**LEVY NUCLEAR PLANT, UNITS 1 AND 2
DOCKET NOS. 52-029 AND 52-030
RESPONSE TO REQUEST FOR ADDITIONAL INFORMATION LETTER NO. 126 RELATED
TO SRP SECTIONS 6.4, CONTROL ROOM HABITABILITY SYSTEM, AND 16, TECHNICAL
SPECIFICATIONS, FOR THE LEVY NUCLEAR PLANT, UNITS 1 AND 2, COMBINED
LICENSE APPLICATION**

**Levy Nuclear Plant Units 1 and 2 (LNP)
Response to NRC Request for Additional Information Letter No. 126 Related to Standard
Review Plan Sections 6.4, Control Room Habitability System, and 16, Technical
Specifications, dated May 13, 2015**

NRC RAI NUMBER: 06.04-5

NRC RAI NUMBER: 16-3

Figure B3.7.6-2

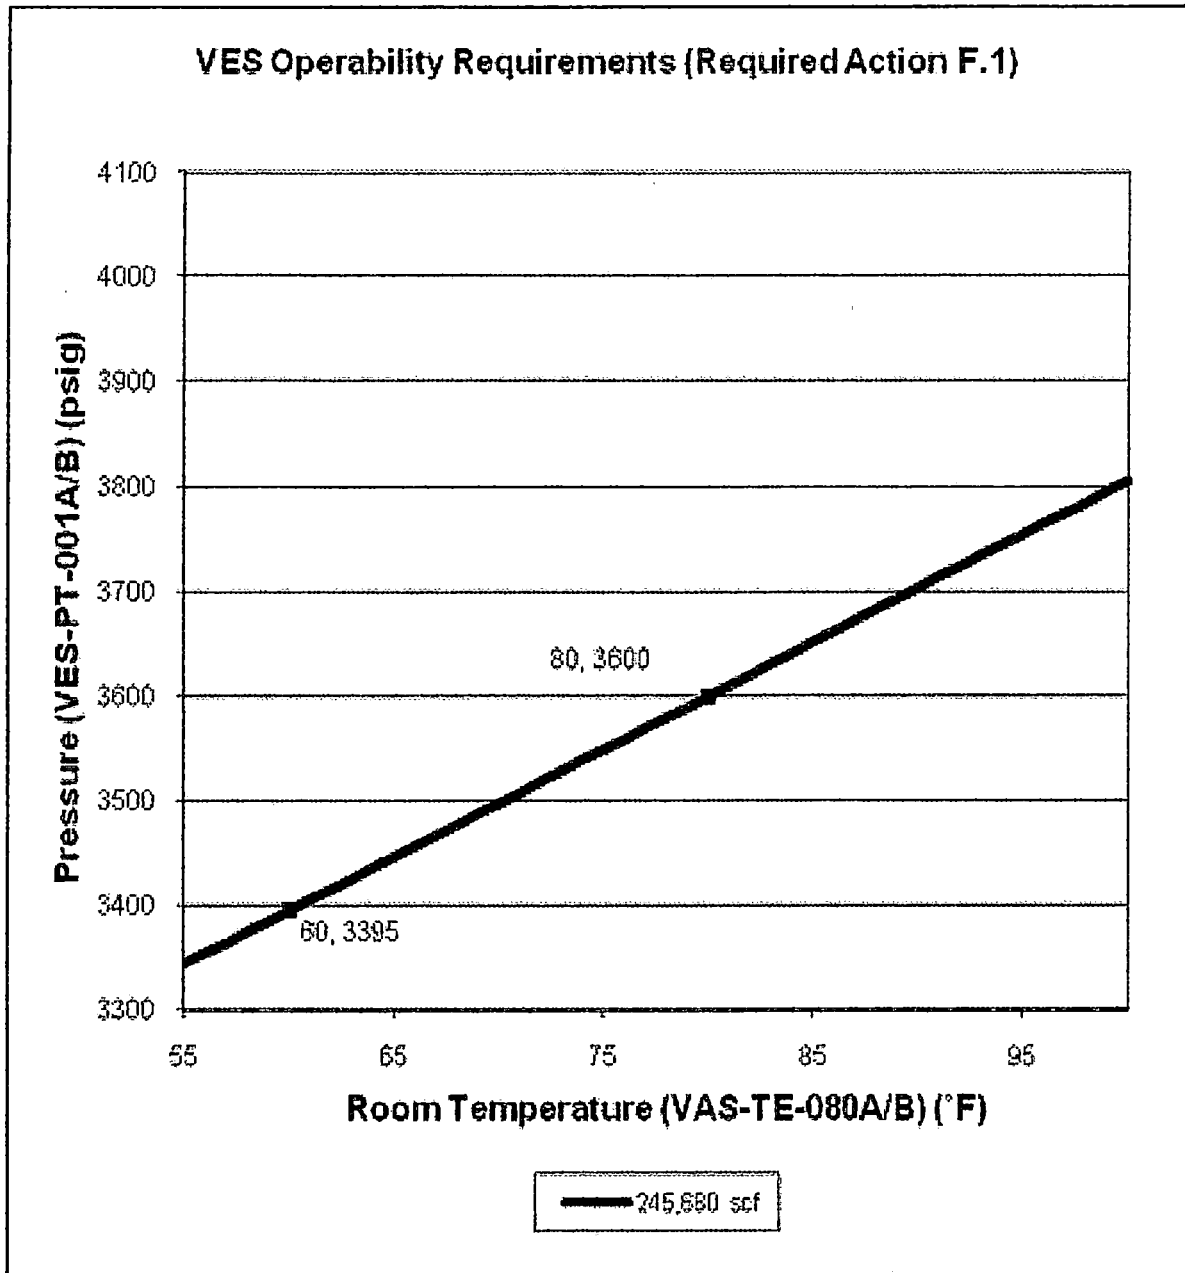
7. Revise Part 4, TS Bases B 3.7.6, Figure B 3.7.6-2, Compressed Air Storage Tanks Minimum Volume - One Bank of VES Air Tanks (8 Tanks) Inoperable, as shown in the Figure B 3.7.6-2 provided below.

Compressed Air Storage Tanks Minimum Volume – One Bank of VES Air Tanks
(8 Tanks) Inoperable
